AGENDA

PLANNING & ZONING COMMISSION REGULAR MEETING WEDNESDAY, SEPTEMBER 13, 2023 - 3:30 PM McALLEN DEVELOPMENT CENTER, 311 N. 15TH STREET, MCALLEN, TEXAS EXECUTIVE CONFERENCE ROOM, PLANNING DEPARTMENT

- a) Casa Corsica Subdivision, 3700 North Ware Road, Graco Real Estates **(SUB2023-0089) (FINAL) KH**
- b) The Villas on Freddy Phase II Subdivision, 1500 Freddy Gonzalez Road, The Villas on Freddy, LLC **(SUB2020-0039) (REVISED FINAL) M&H**
- c) Journey Church Subdivision, 7001 State Highway 107, Journey Church RGV, Inc. **(SUB2023-0091) (PRELIMINARY) MGE**
- d) Rancho Valencia Subdivision, 1200 East El Rancho Road, Francisco Pons Ballesteros, **(SUB2023-0090) (FINAL) MGE**
- e) Encino Estates Subdivision, 6700 North Shary Road, Silver Candle Holdings, LLC, **(SUB2023-0088) (PRELIMINARY) BIG**
- f) Villas at Northgate Subdivision, 1701 Northgate Lane, Lourdes Gabriela Vela **(SUB2023-0087) (PRELIMINARY) RDE**

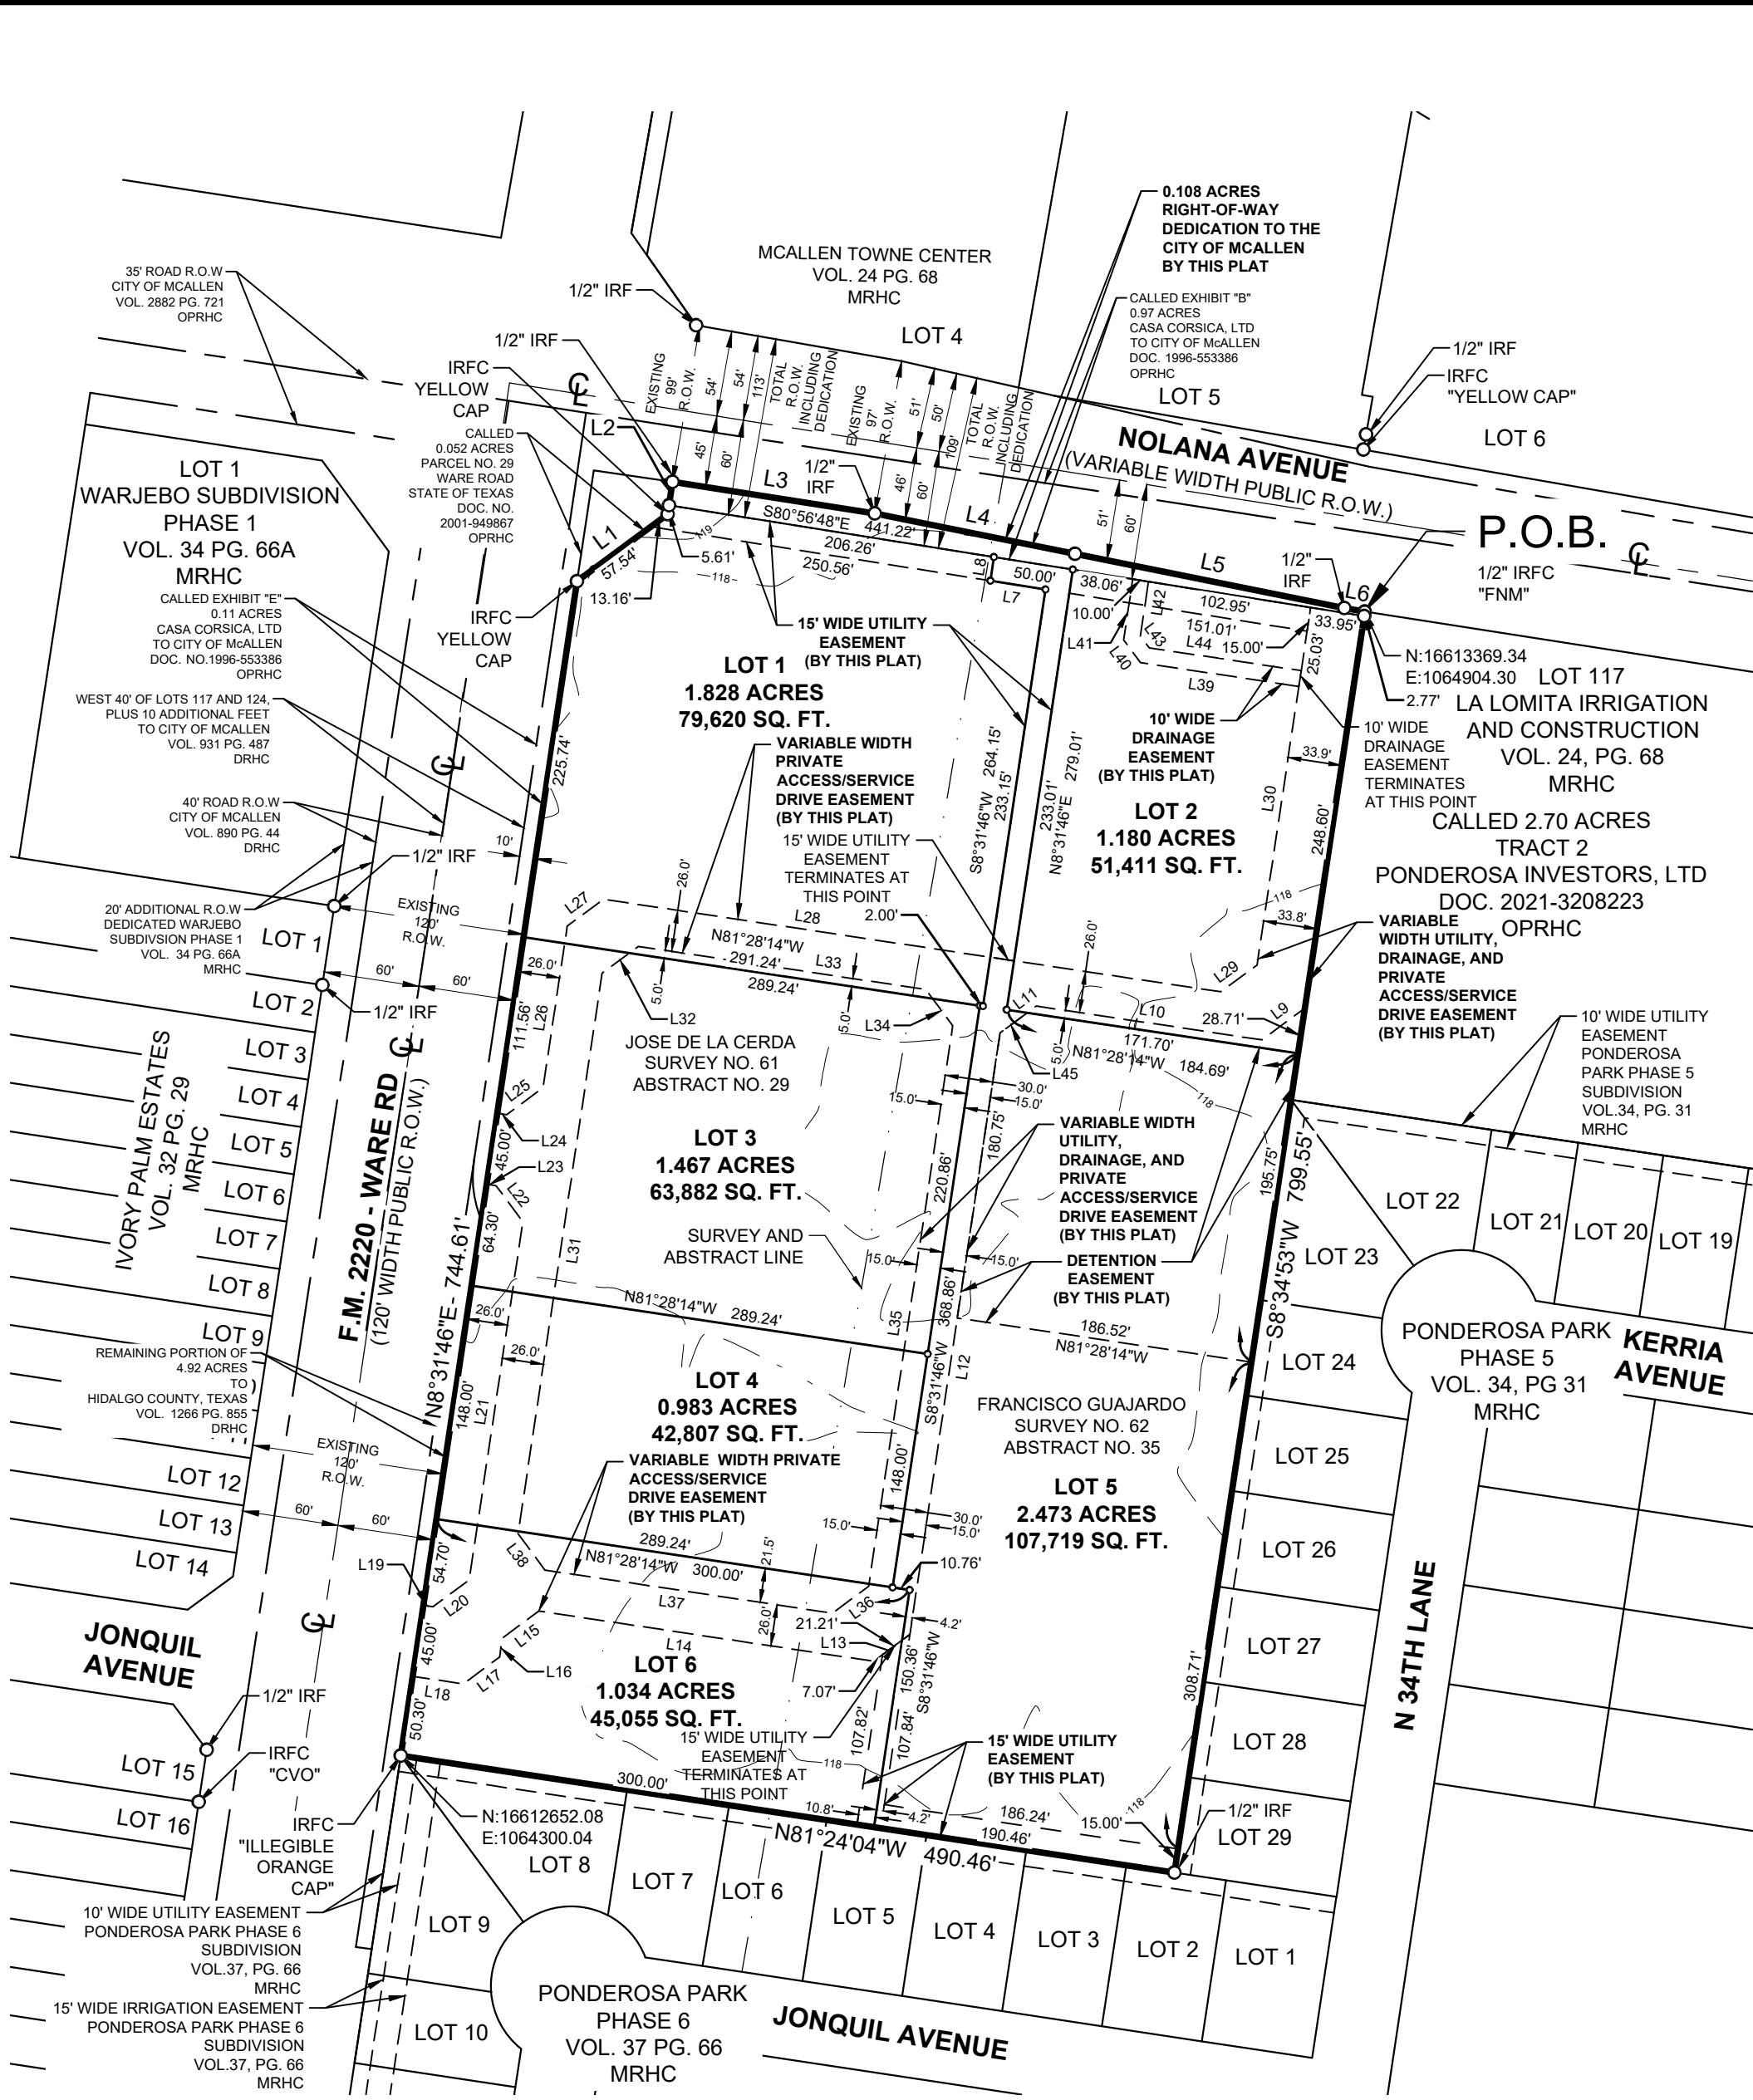
Required
COMMENTS	
<p>Comments:</p> <ul style="list-style-type: none"> - Use Sec. 134-61 of the subdivision ordinance for the signature blocks' wording, including the owner's acknowledgement prior to recording and clarify why there are two owner's signature blocks. *Must comply with City's Access Management Policy. *The Planning and Zoning Commission approved the subdivision in preliminary form at the meeting of June 6, 2023, subject to the conditions noted, drainage, and Utilities approval. * As per the Utilities Department, the subdivision has received MPU Board approval. 	Required

SUBDIVISION MAP OF
THE VILLAS ON FREDDY PHASE II

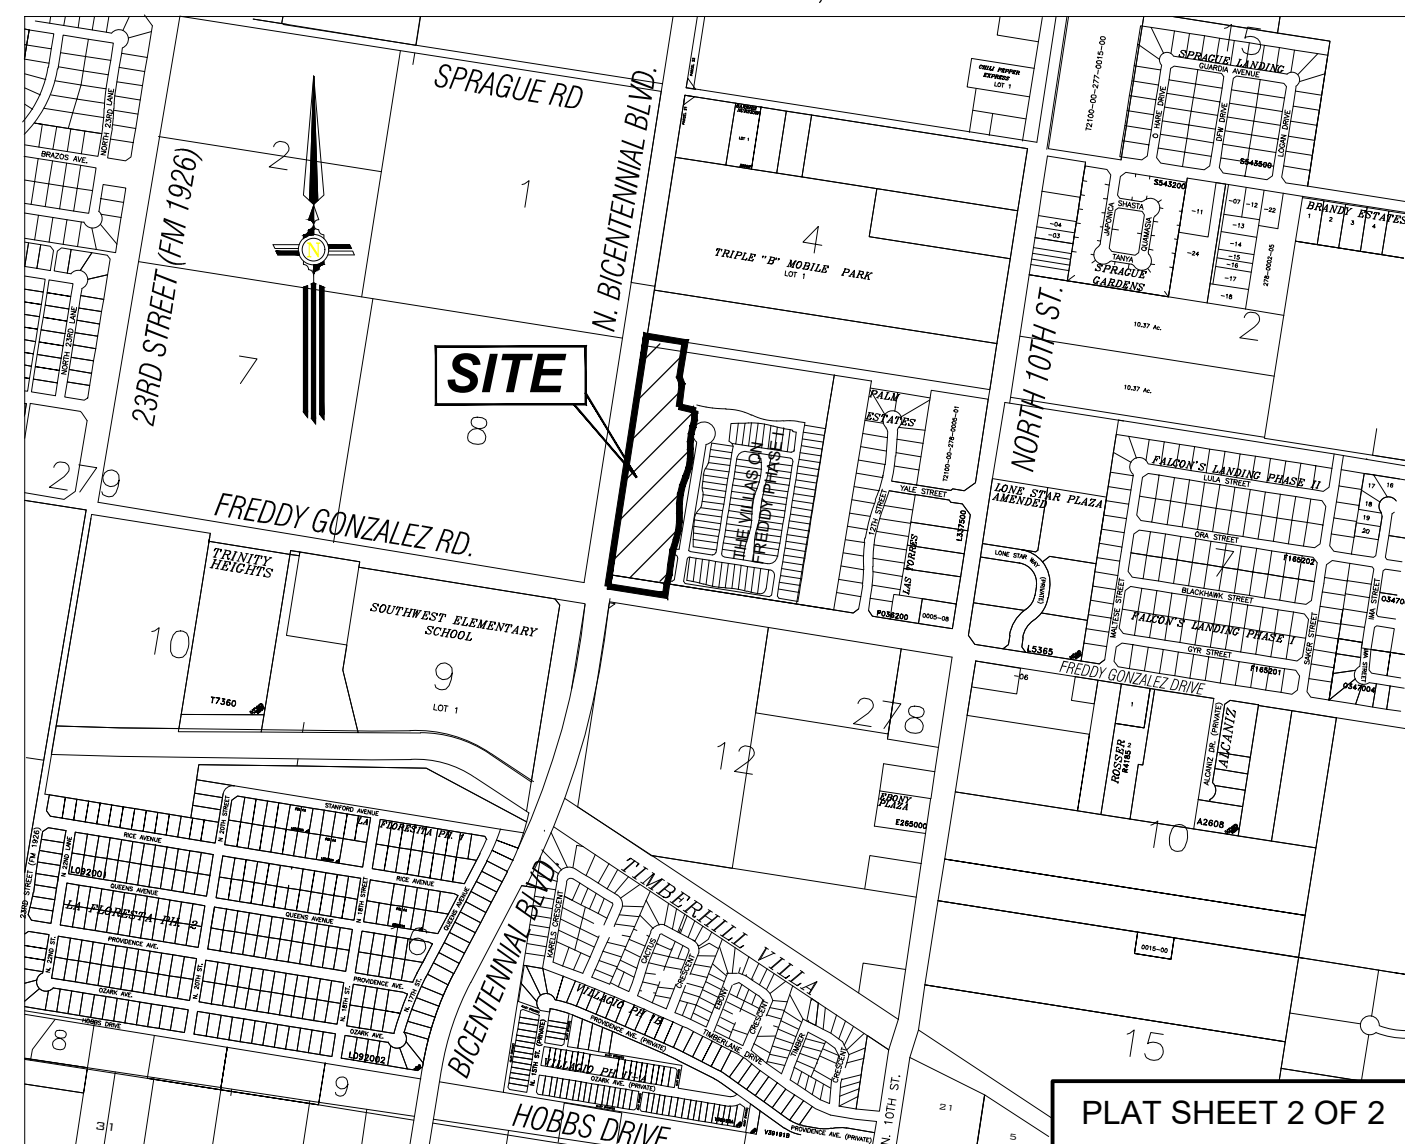
Based on The sidewalks plans submitted in 2019, the sidewalks were proposed to be built along the rear side of the lots, not at the front. The engineer requested a variance for 20 ft. garage setback to match The Villas on Freddy Phase I Subdivision, with a proposed note as shown above. The variance request was approved by the Planning and Zoning commission on July 12, 2023.

***Setbacks under plat note #3 must be revised as previously approved for TVOF II prior to recording. If any changes are proposed, variance might be required.

***Plat note #3 to be revised as shown above prior to recording.
